U.S. DEPARTMENT OF THE INTERIOR
BUREAU OF RECLAMATION
NAVAJO-GALLUP WATER SUPPLY PROJECT
NEW MEXICO

SAN JUAN LATERAL - BLOCK 2 - 3

REACH 3 - LINE PIPE

PLAN AND PROFILE

1695-D-60783

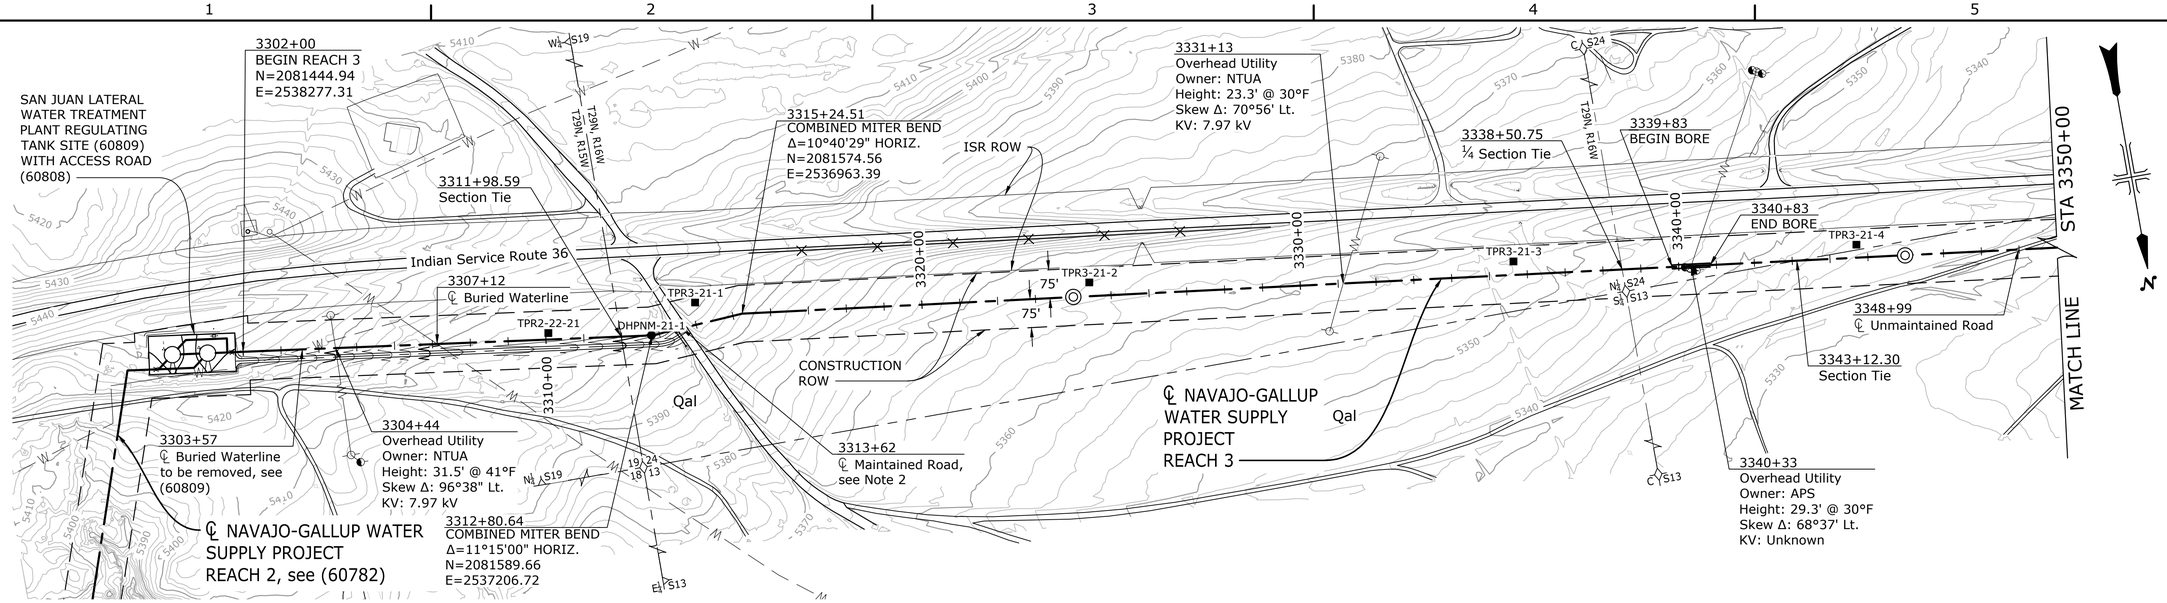
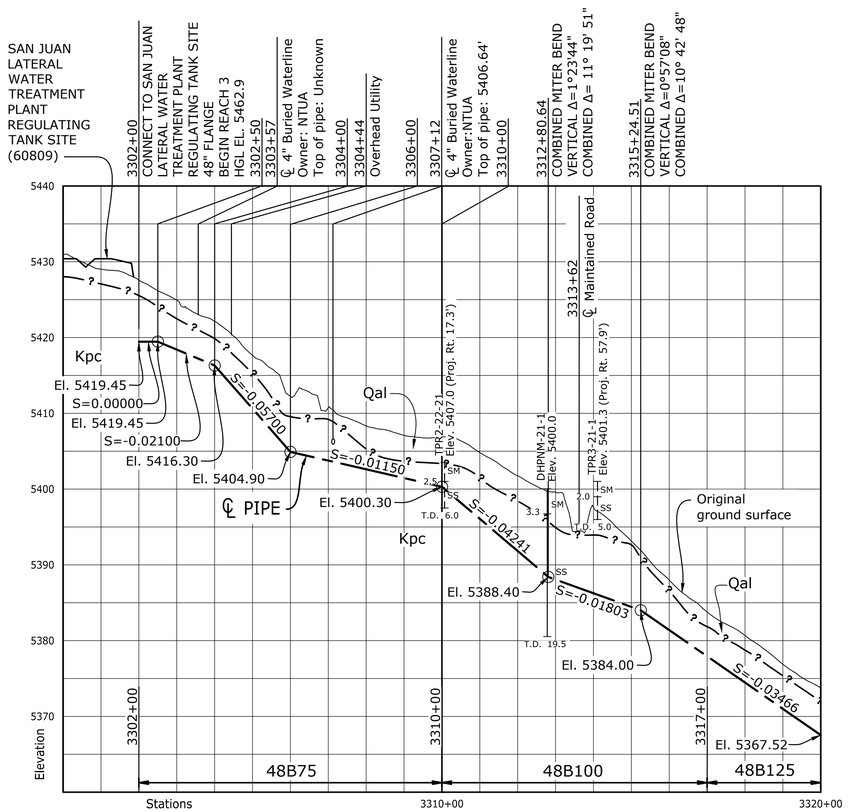
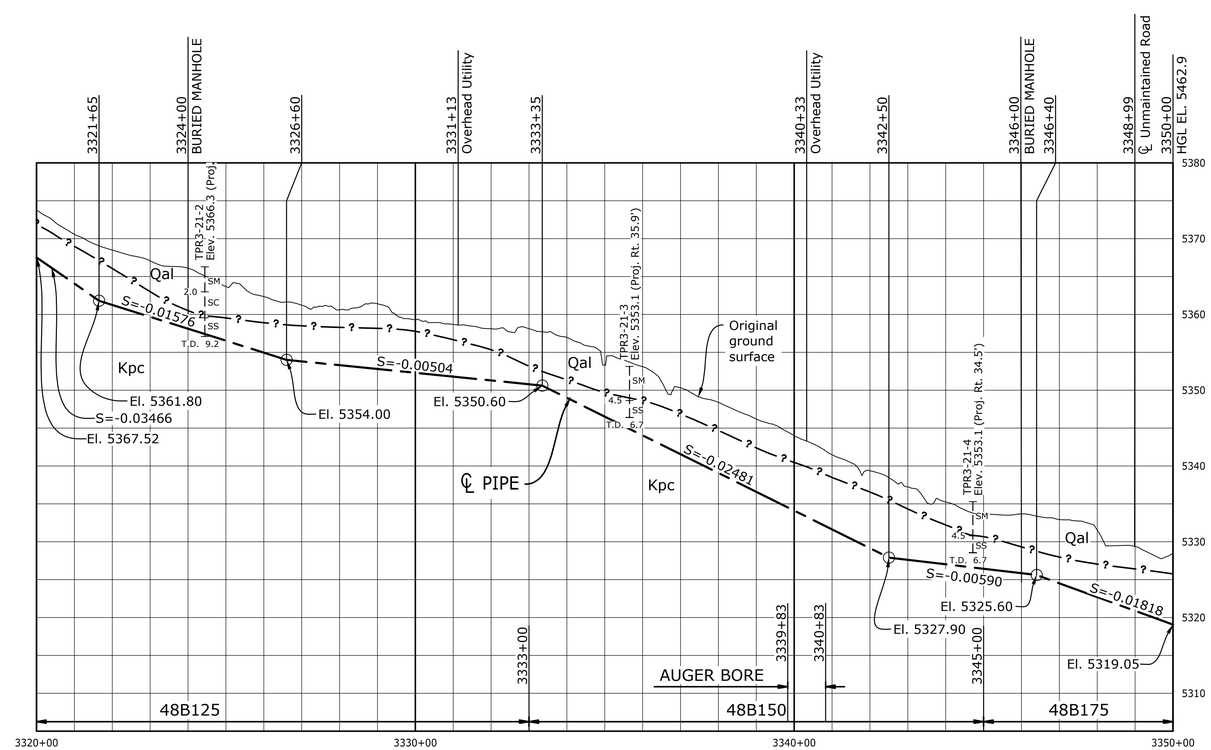
REV NO			
1	D	2026-05-18	Removed auger bore for powerline crossing at Station 3331+13
		Marner, Andrew (Andy) J P.E.

1695-D-60788

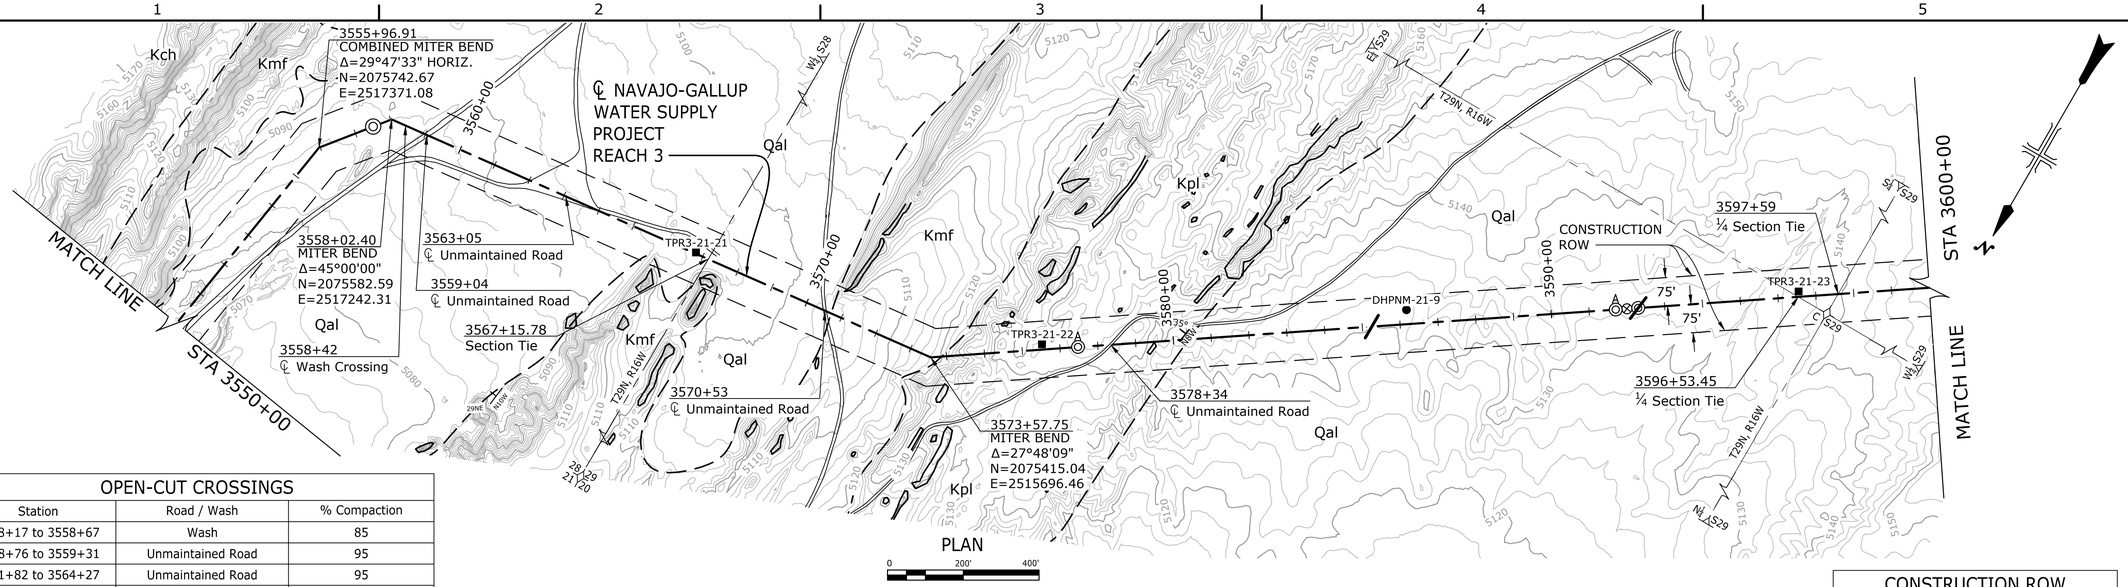
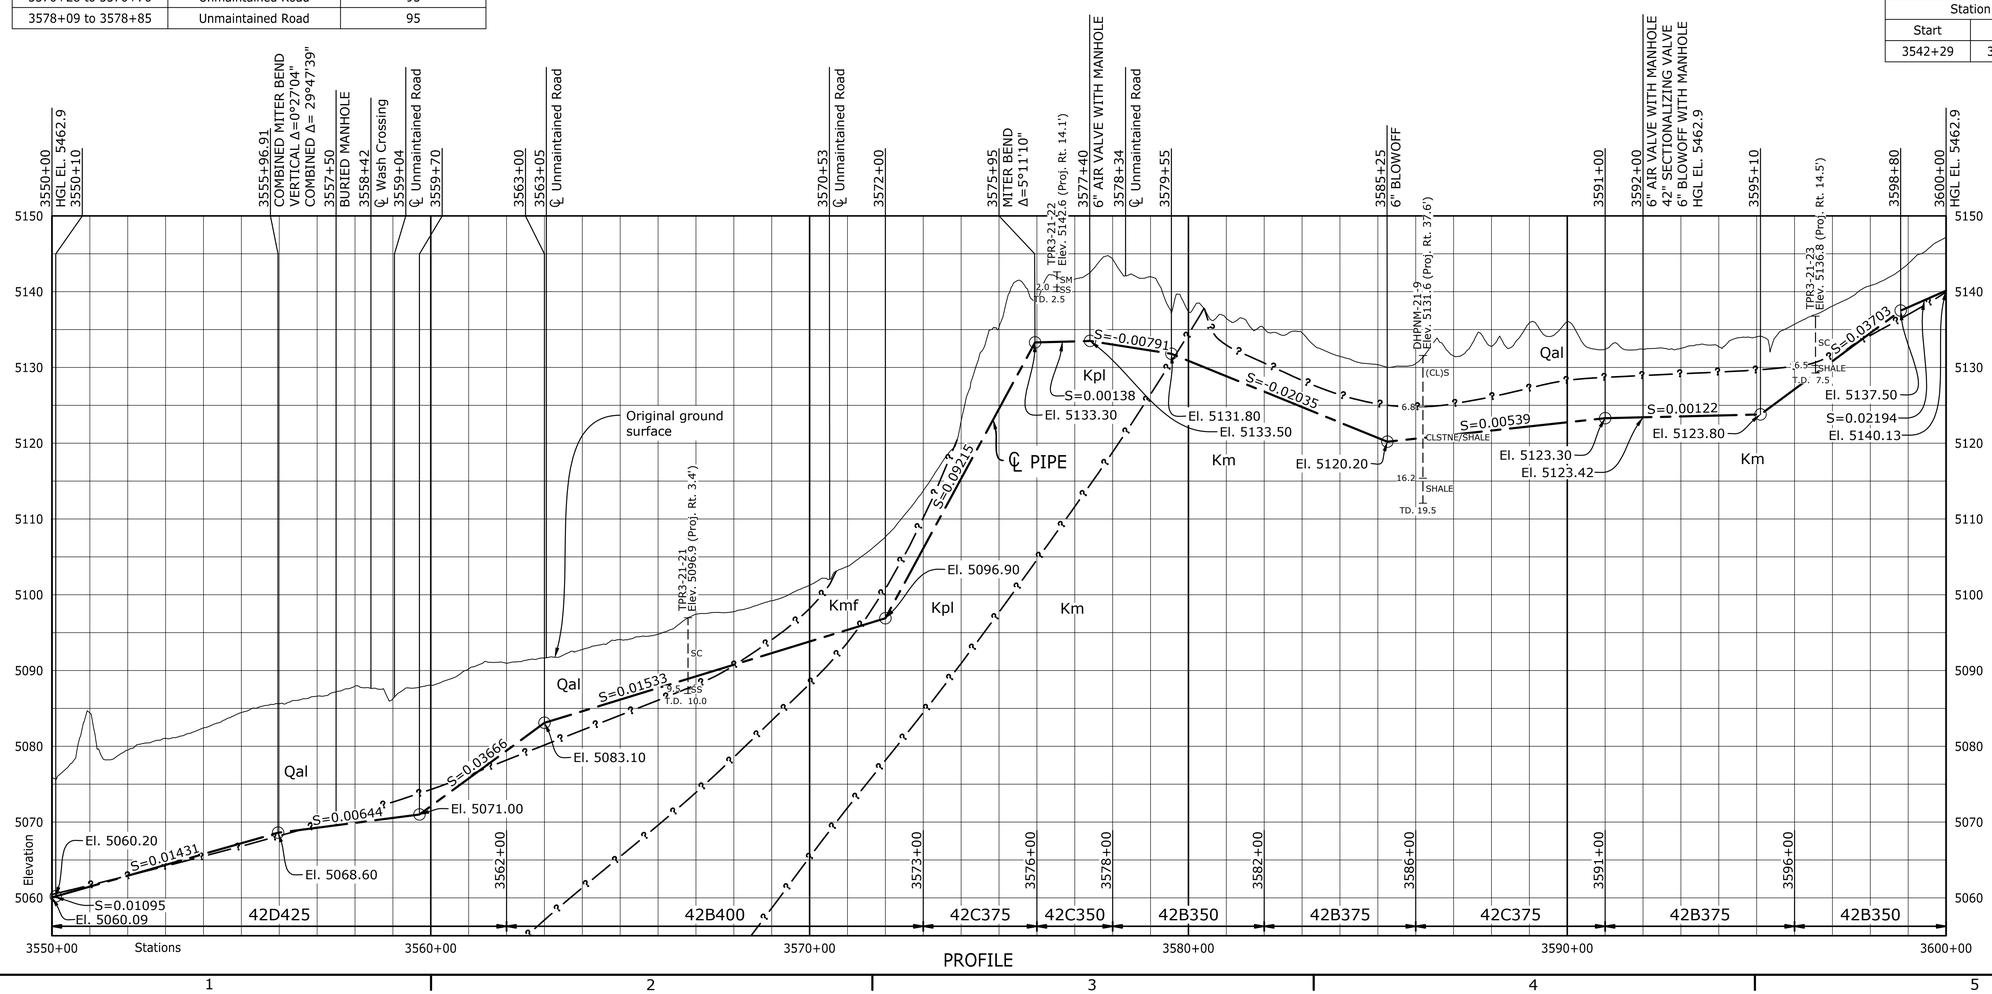
REV NO		
1	2026-05-18 Marner, Andrew (Andy) J P.E.	D Added missing miter bend angle information for Station 3575+95.

1695-D-60789

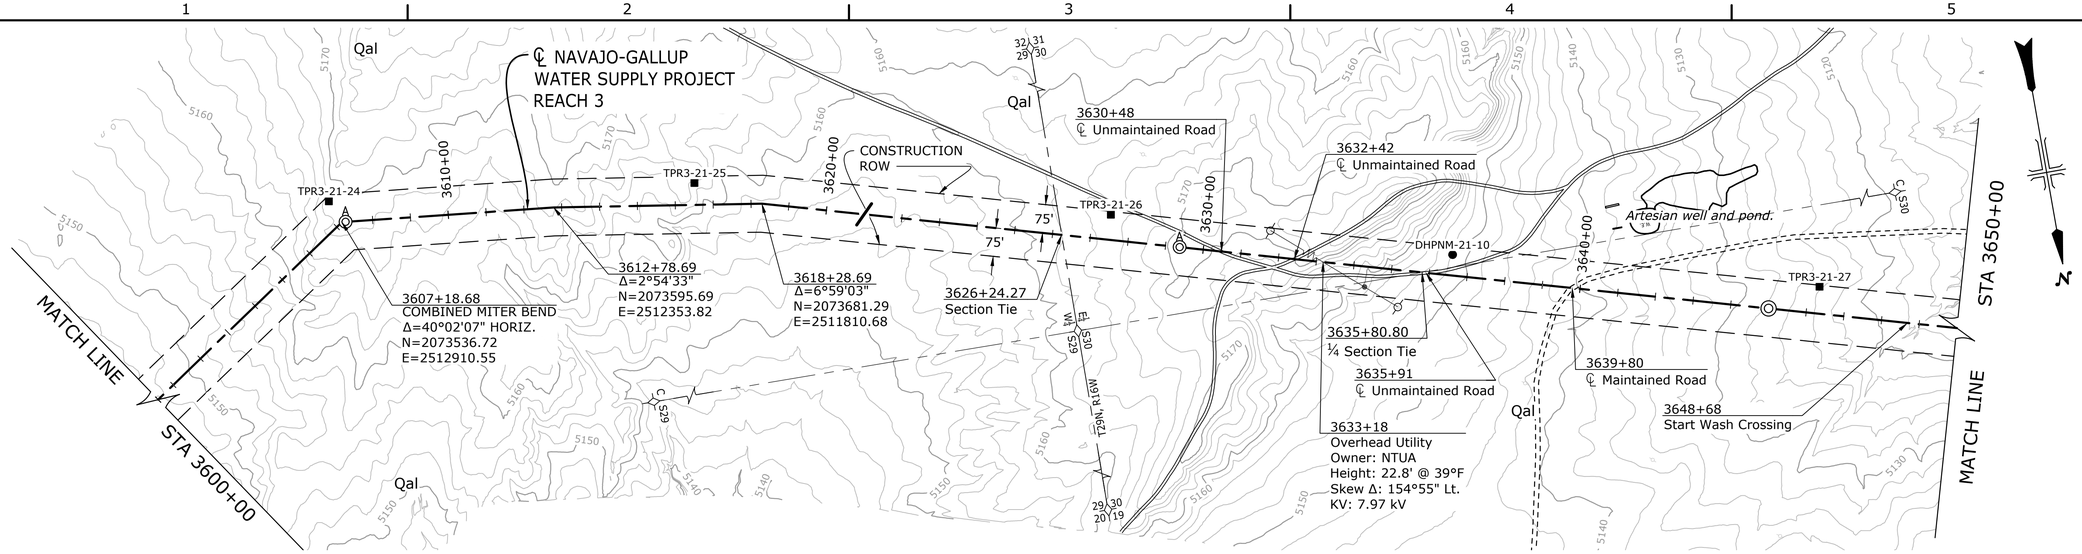
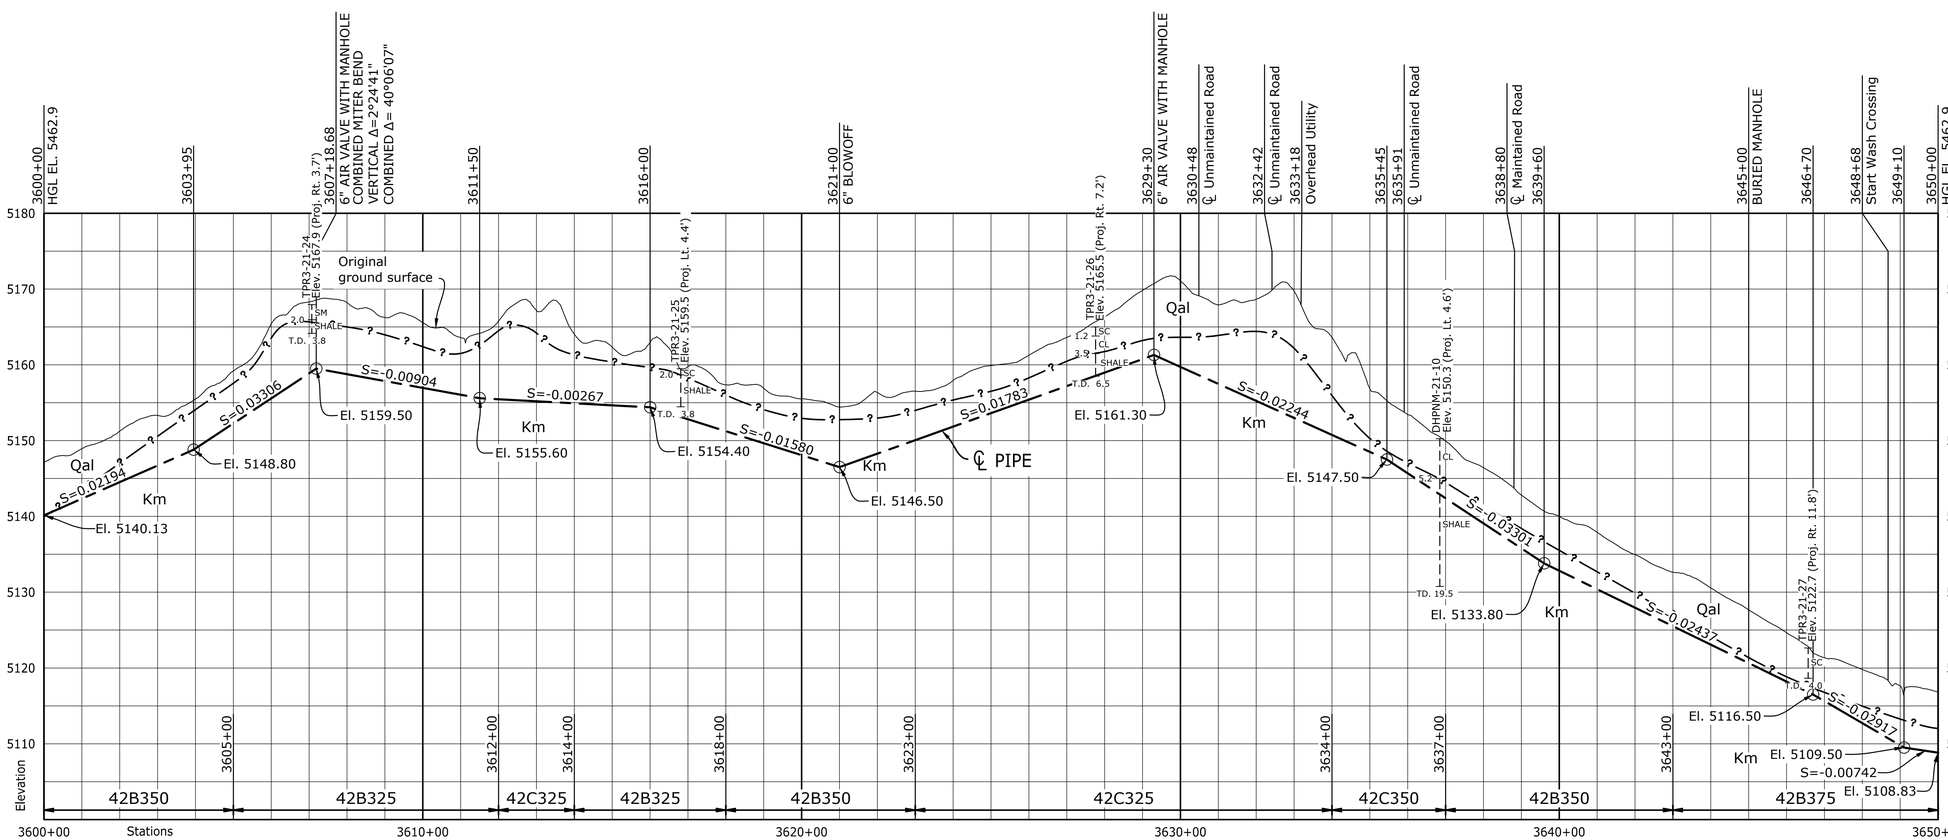
REV NO		
1	2026-05-18 Marner, Andrew (Andy) J P.E.	D Removed auger bore for powerline crossing at Station 3633+18.
